ADDENDUM NO. ONE
NCSB -FBMS

To the Plans and Specifications for:
Nassau County School Board – Project No. 98110-031
Fernandina Beach Middle School Kitchen / Dining Remodeling and Campus
Renovations/Enhancements

Date: October 15, 2018

E-2

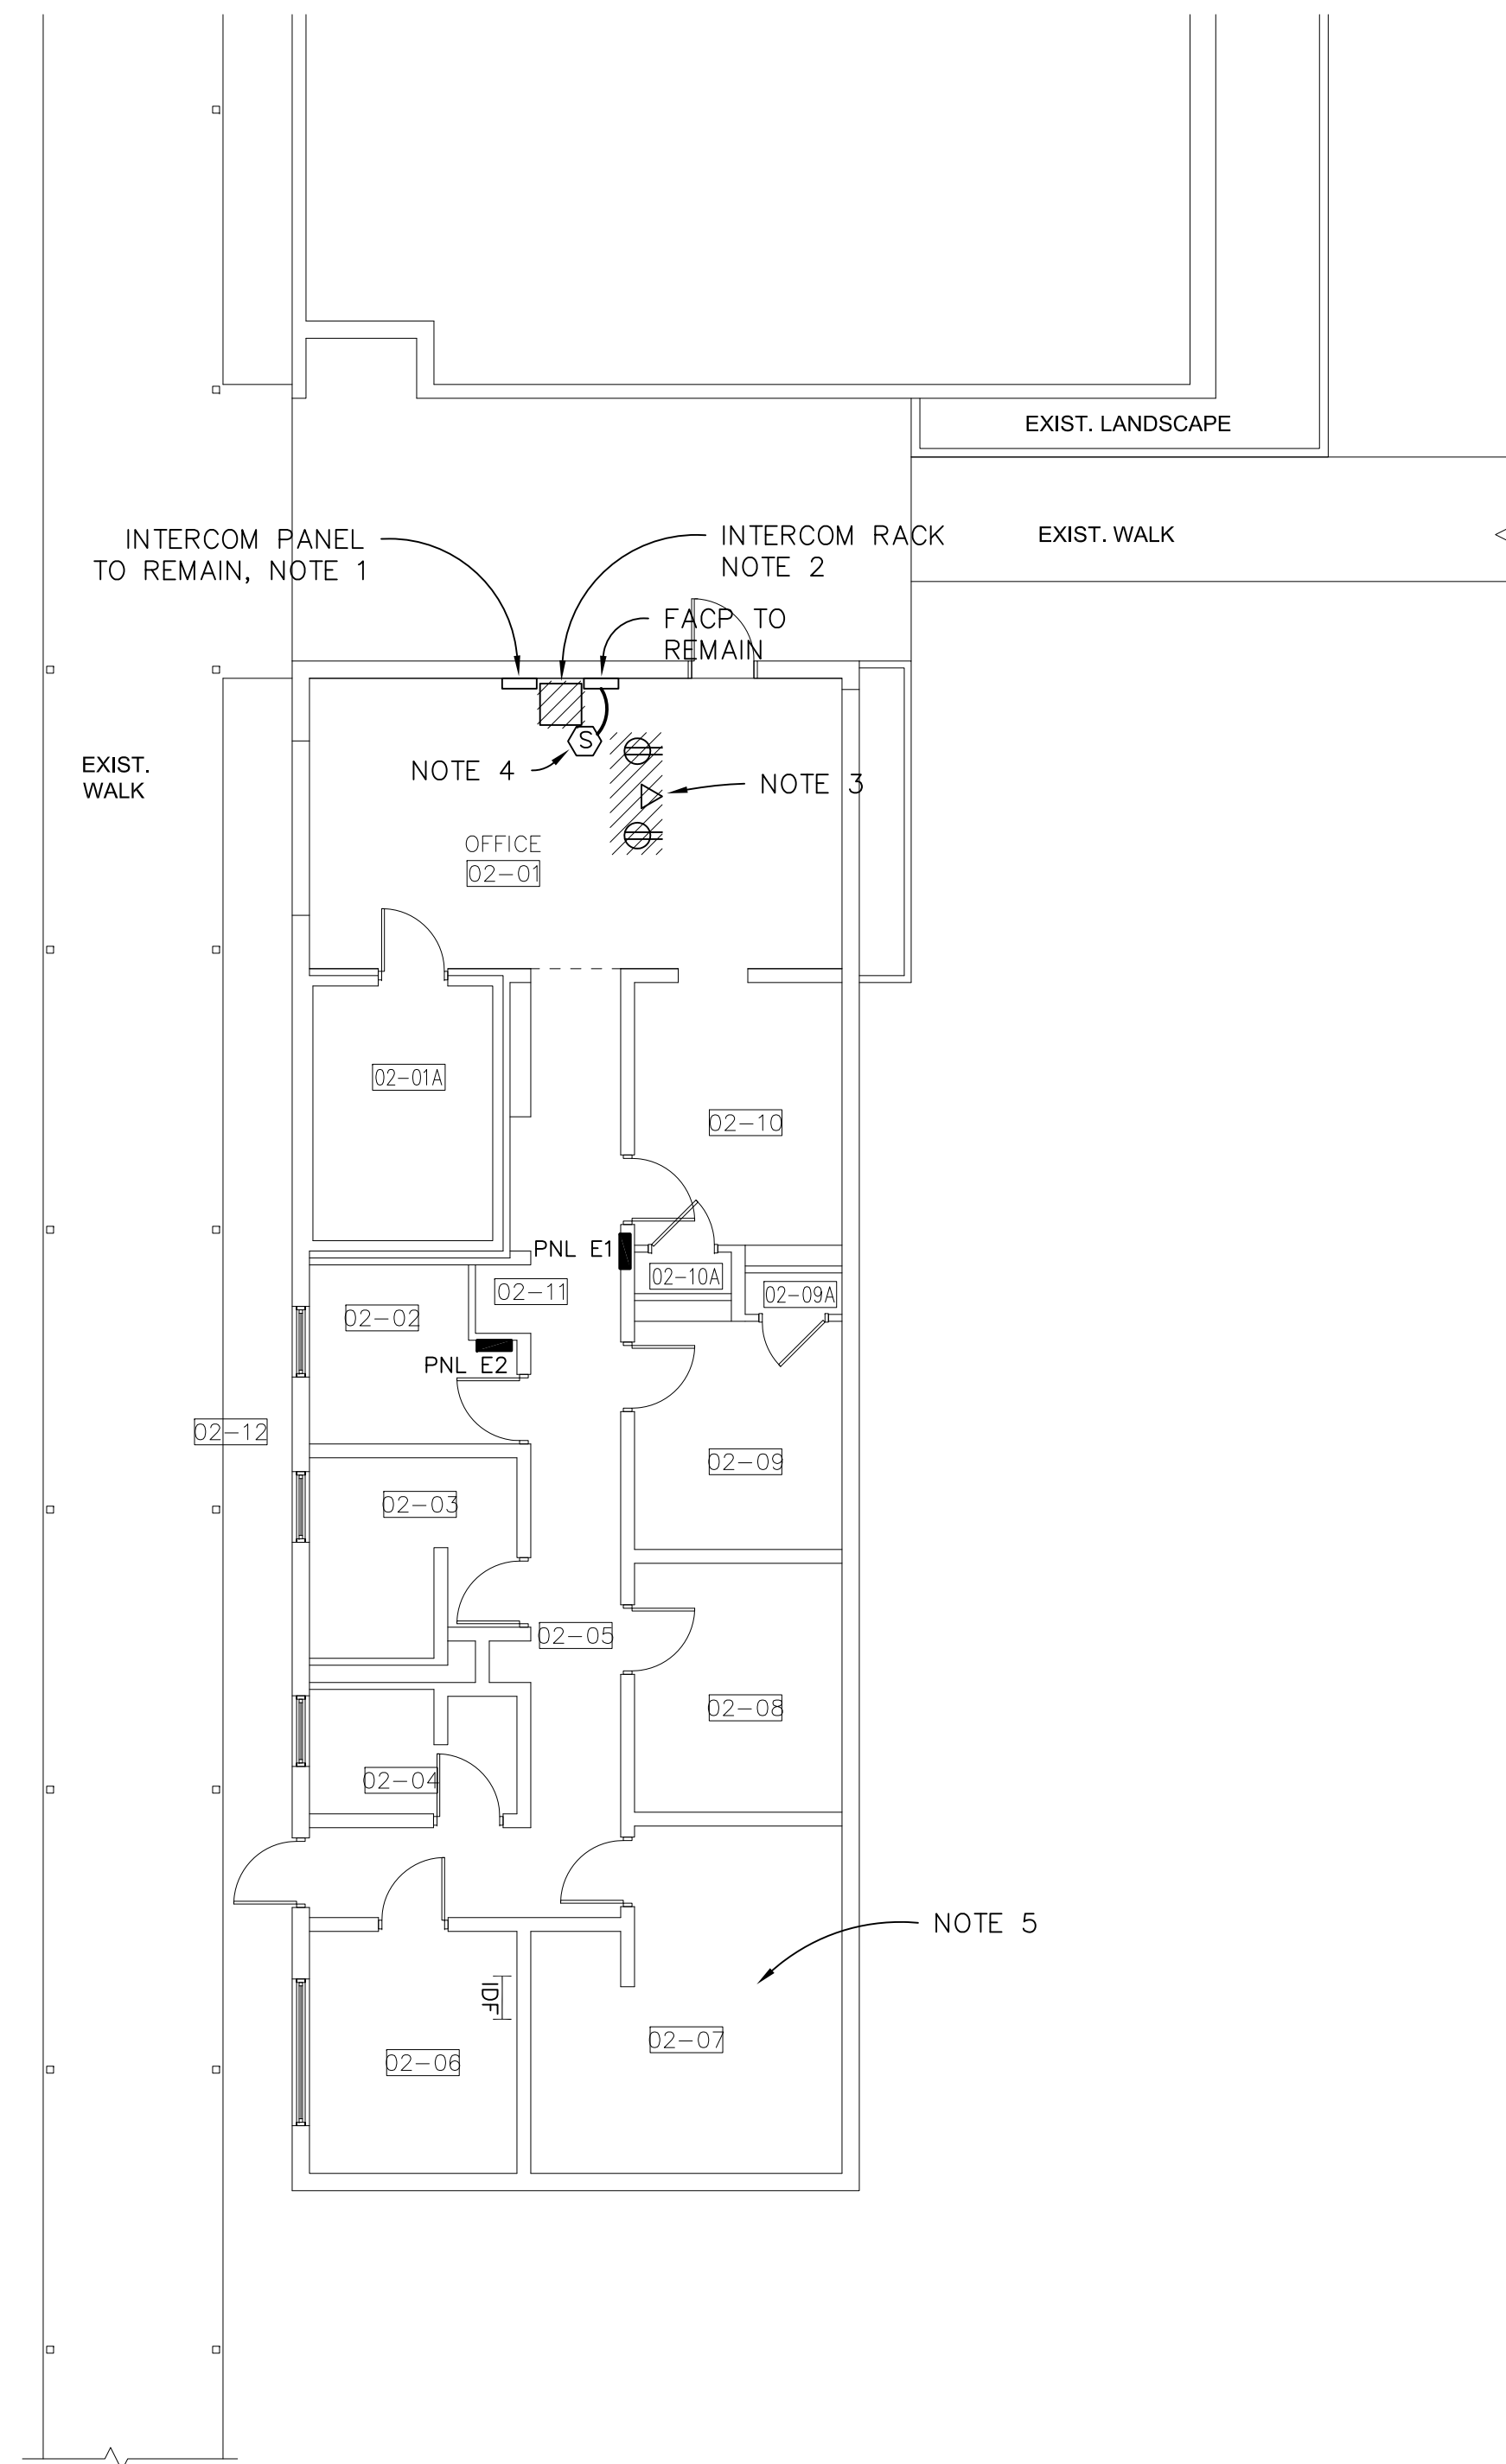
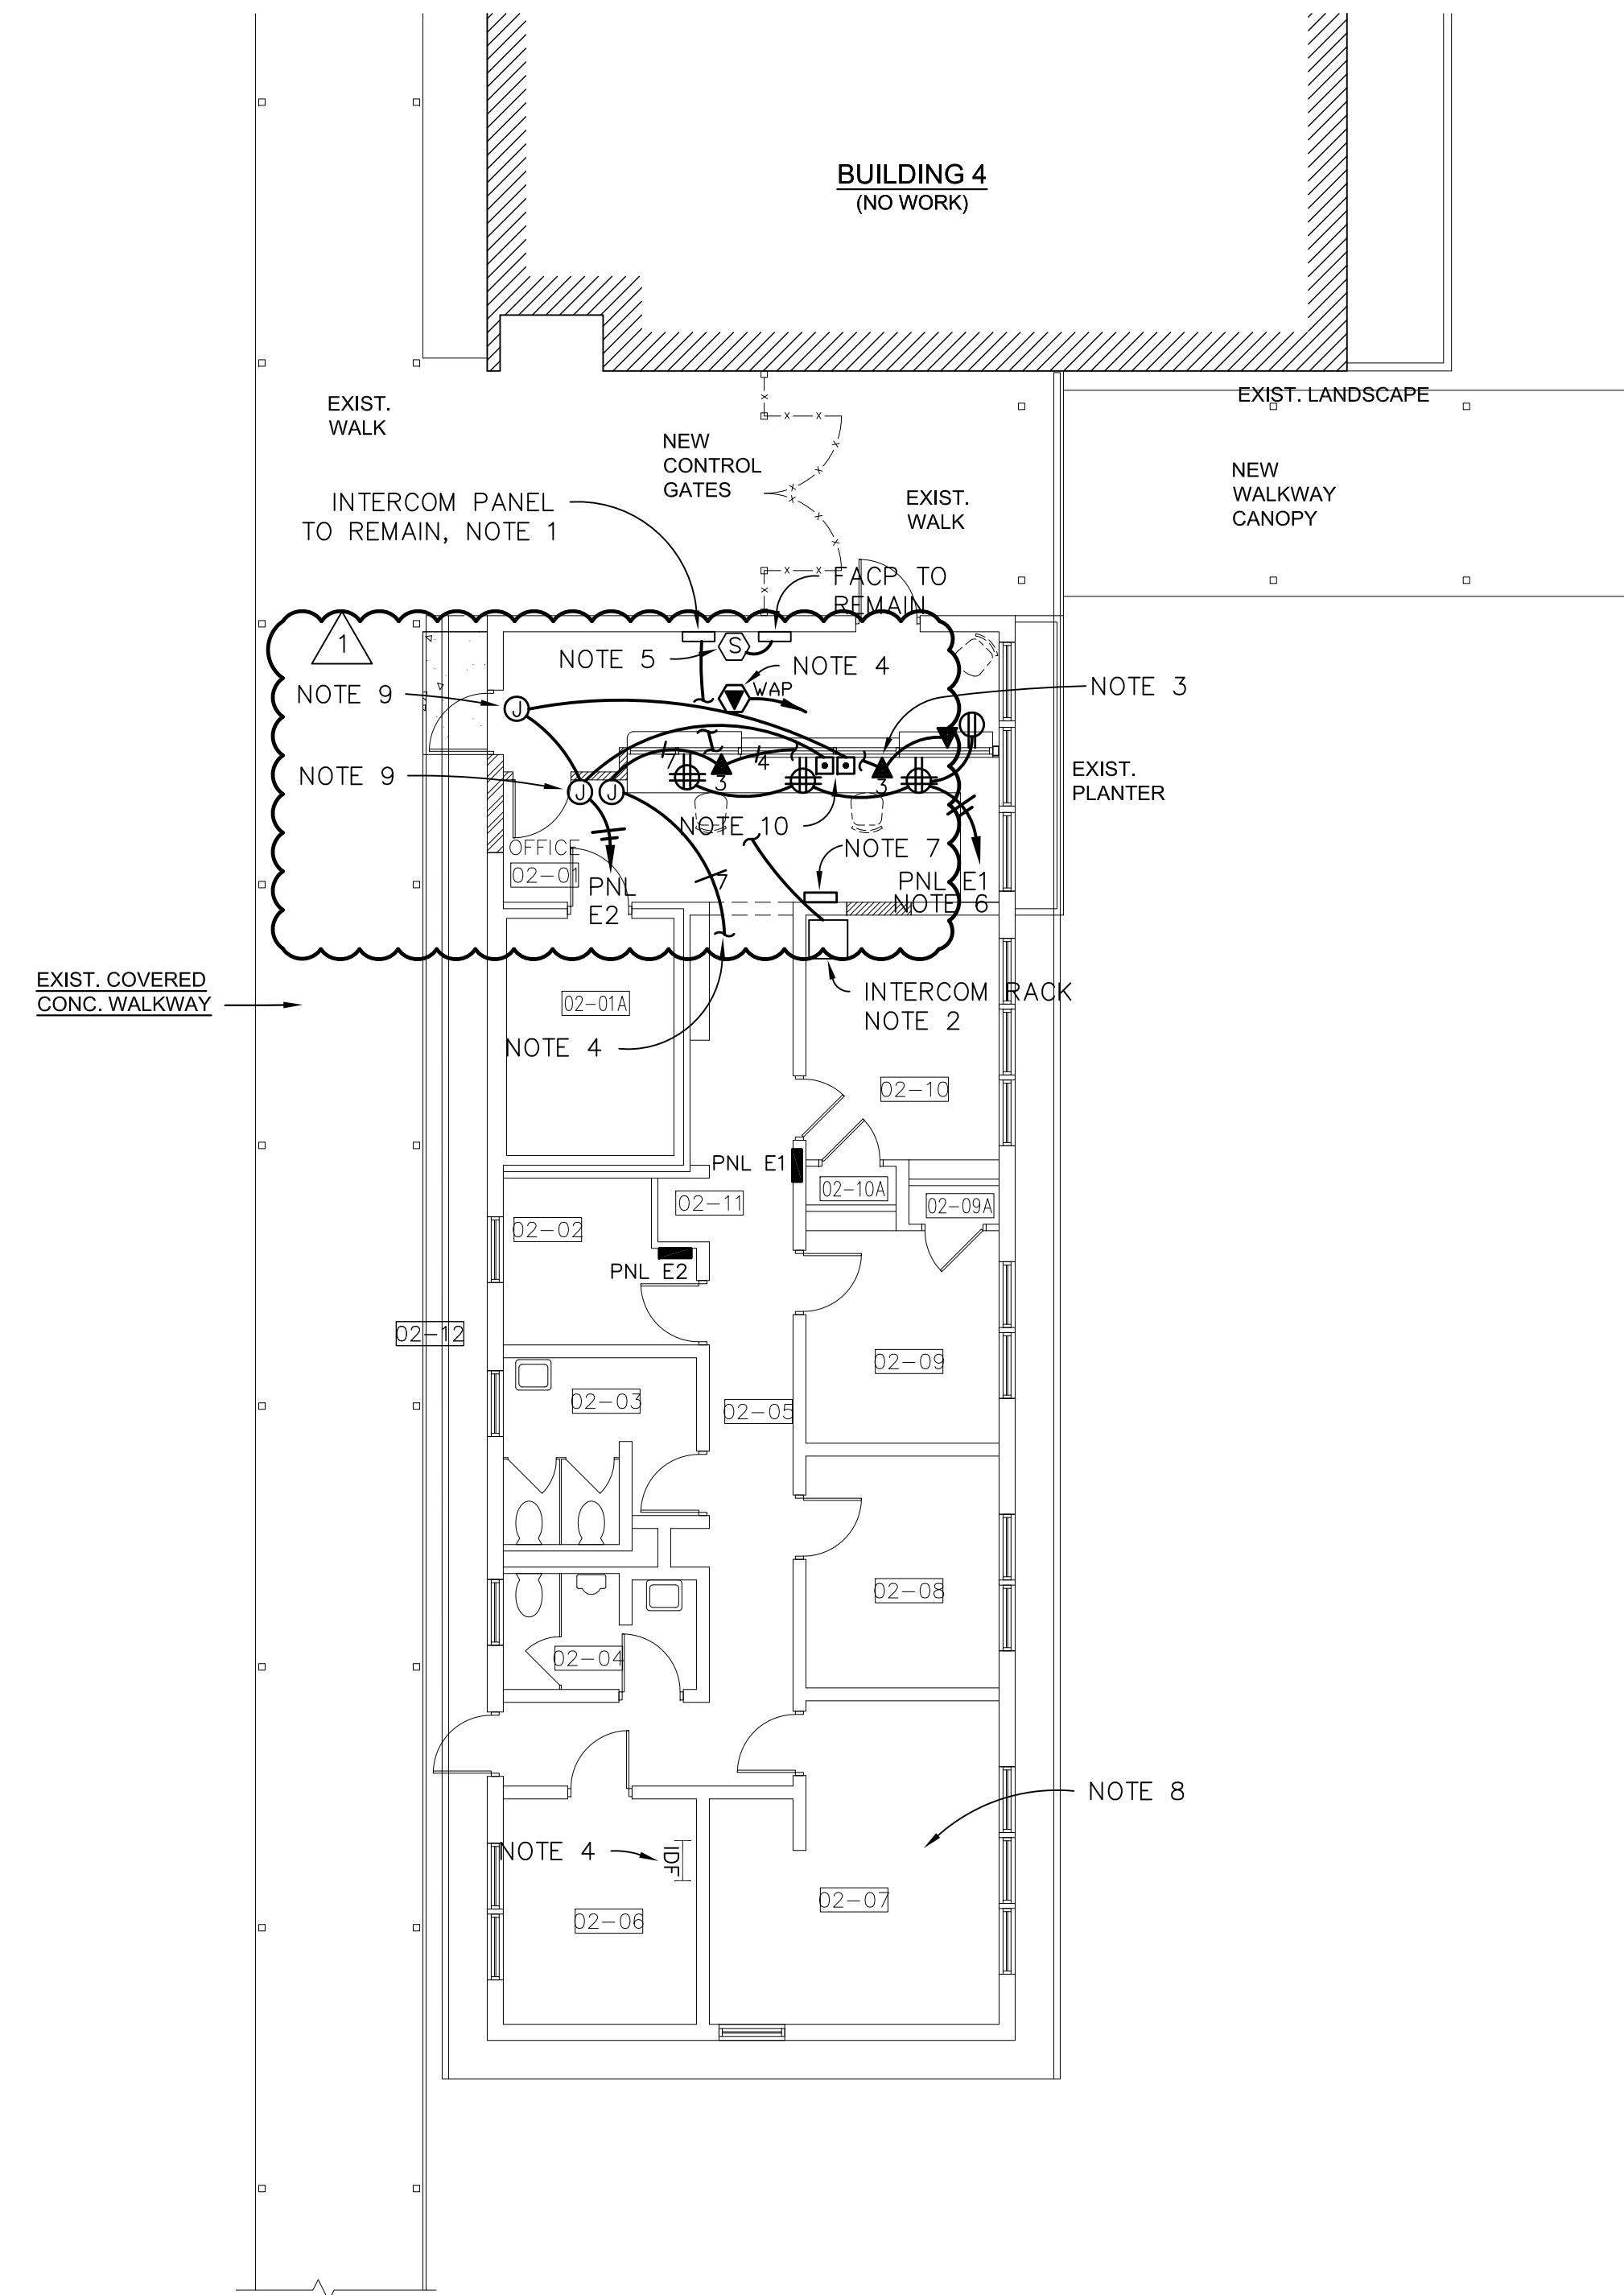
- a. Delete existing Drawing and insert attached new Drawing dated October 15, 2018.
- b. See revised power, communications and door control wiring.
- c. See revised Note 9 and new Note 10.

BUILDING 02 NEW HVAC POWER PLAN	
DATE	9-25-2018
D.B.	LMC
C.B.	LMC
JOB NO.	18016

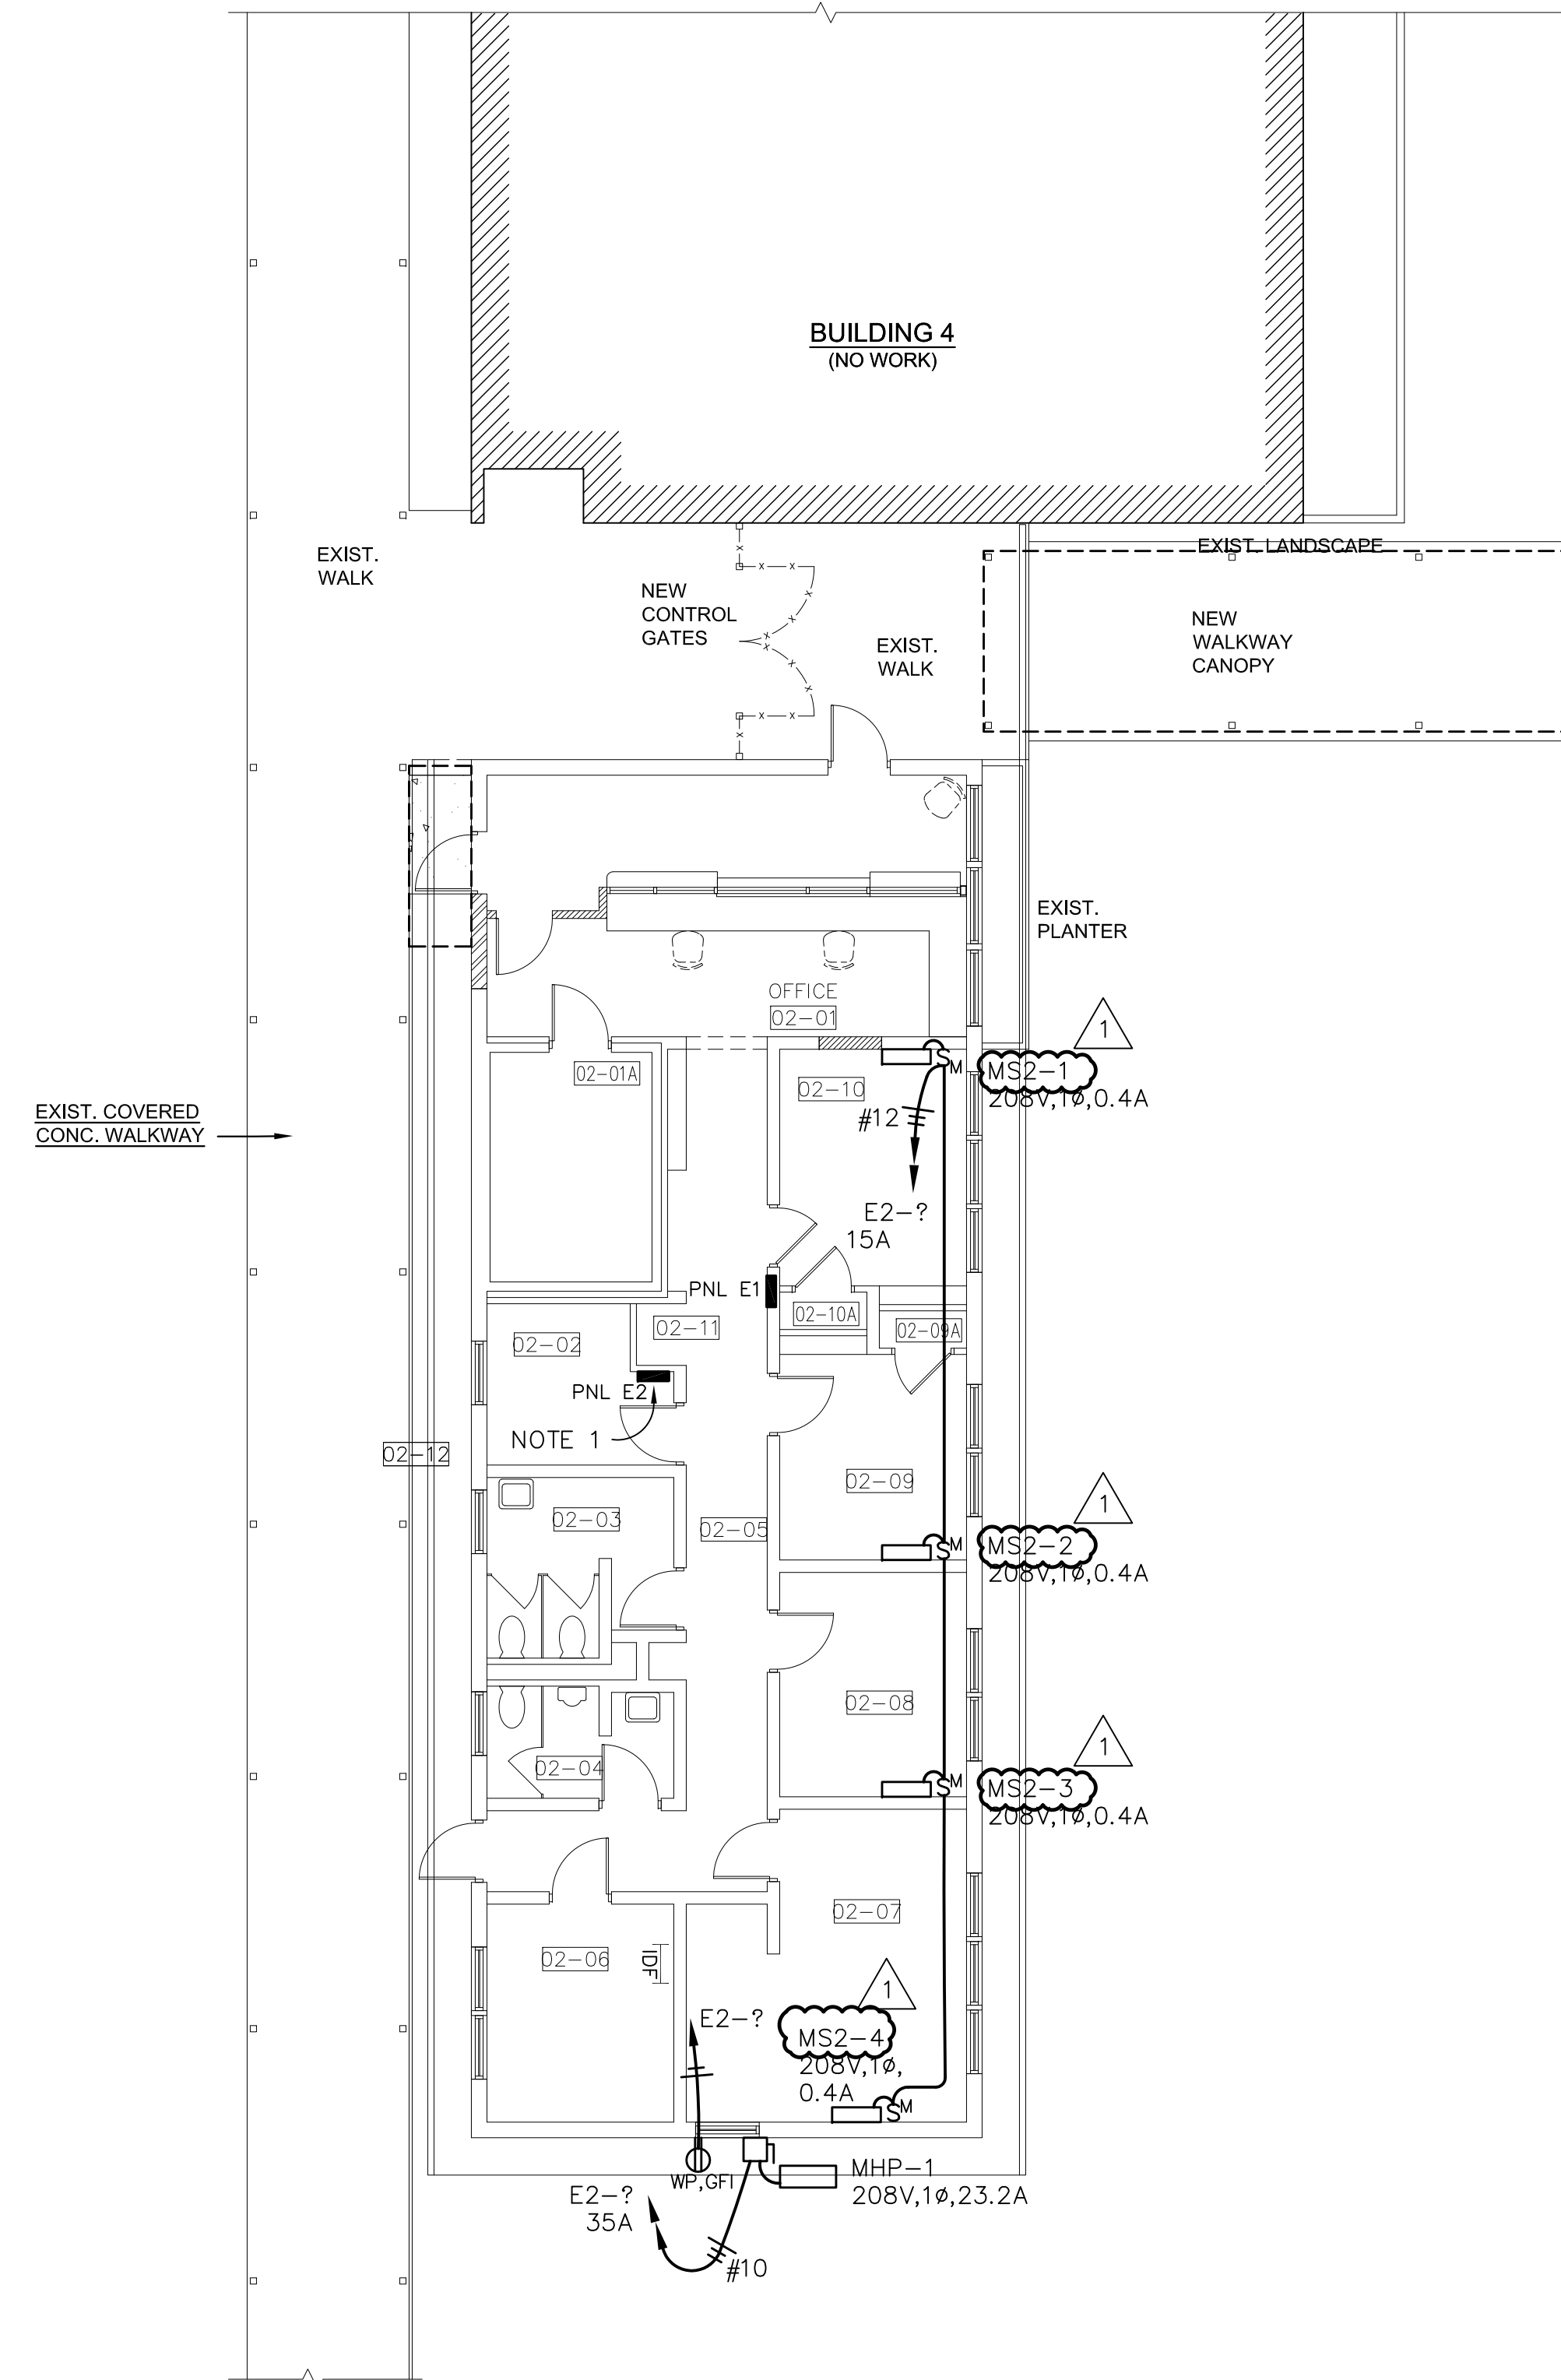
- a. Delete existing Drawing and insert attached new Drawing dated October 15, 2018.
- b. See revised mini-split AHU numbering.
